Metropolitan Historic Zoning Commission
Sunnyside in Sevier Park
3000 Granny White Pike
Nashville, Tennessee 37204
Telephone: (615) 862-7970

STAFF RECOMMENDATION 1903 Fatherland St January 20, 2021

Application: New Construction—Addition; Setback Determination
District: Lockeland Springs-East End Neighborhood Conservation Zoning Overlay
Council District: 06
Base Zoning: R6
Map and Parcel Number: 08314017200
Applicant: Arlie Dulaney, Contractor
Project Lead: Sean Alexander, sean.alexander@nashville.gov

SOUTH ELEVATION
STREET VIEW
1903 FATHERLAND
NASHVILLE, TN

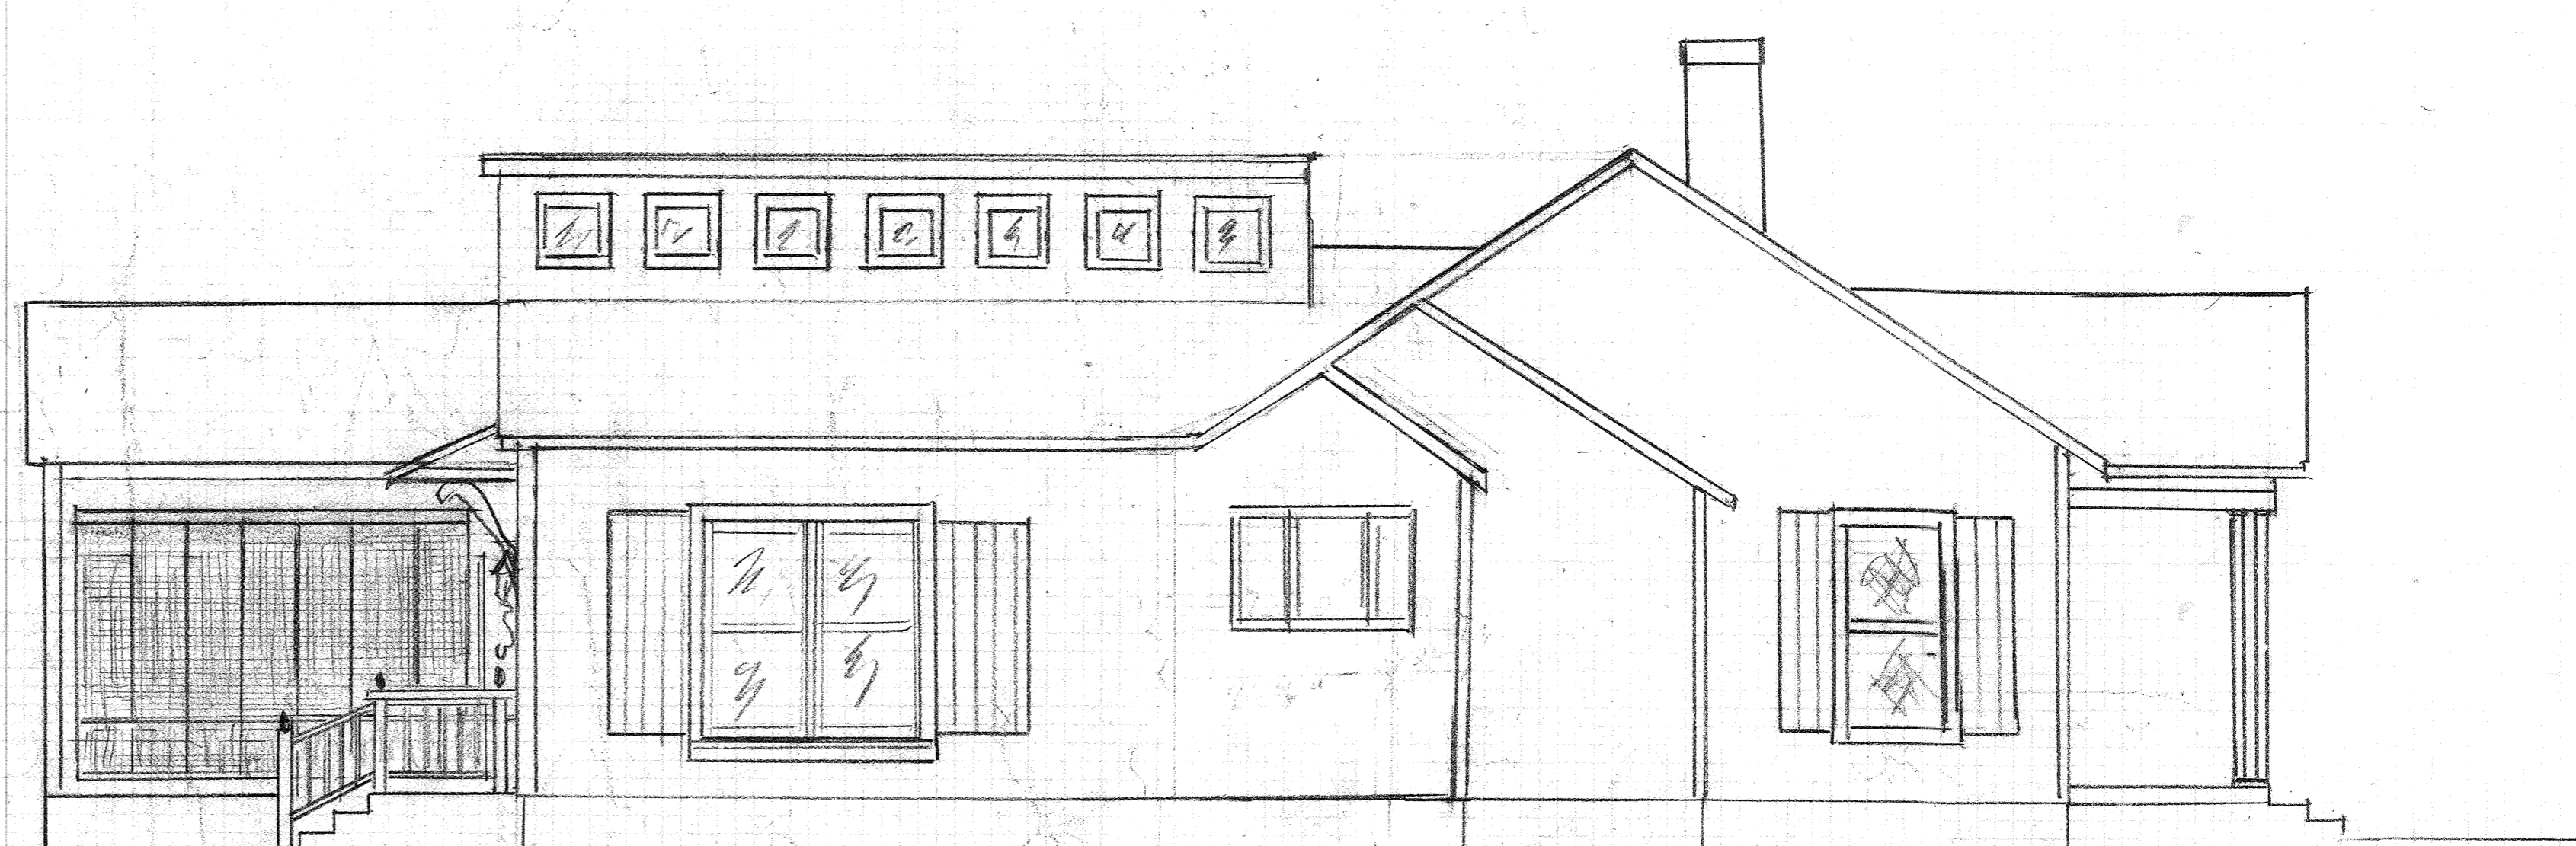
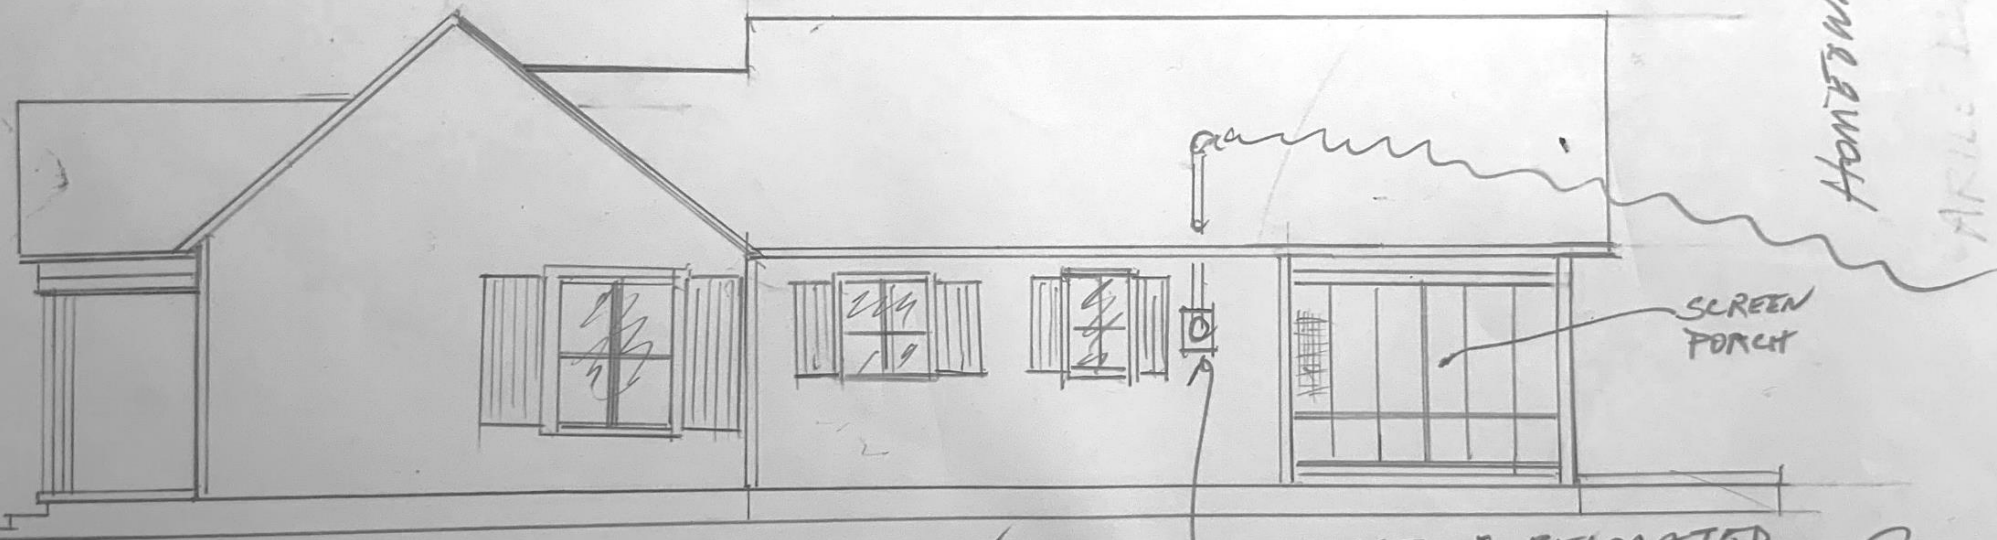
Proportion and Rhythm of Openings: The addition will have windows with proportions and rhythm compatible with the existing building, with the exception of two round windows on the front wall of the left side addition. The windows on the historic house, and on Craftsman houses typically, are rectangular. The rear portion of the addition will have a clerestory component with a row of square windows just below the roof ridge. While these windows are not typical of historic houses, this component is behind the original roof and will not be visible from the right of way.

With a condition that the front-facing windows are rectangular, Staff finds that the window proportion and rhythm of openings are generally compatible with the historic house and that the project will meet section II.B.7 of the design guidelines.

1. Additional information about the foundation material, wall cladding, and roofing is approved prior to construction;
2. The front-facing windows on the addition are rectangular; and
3. The window and door selections are approved prior to purchase and construction.
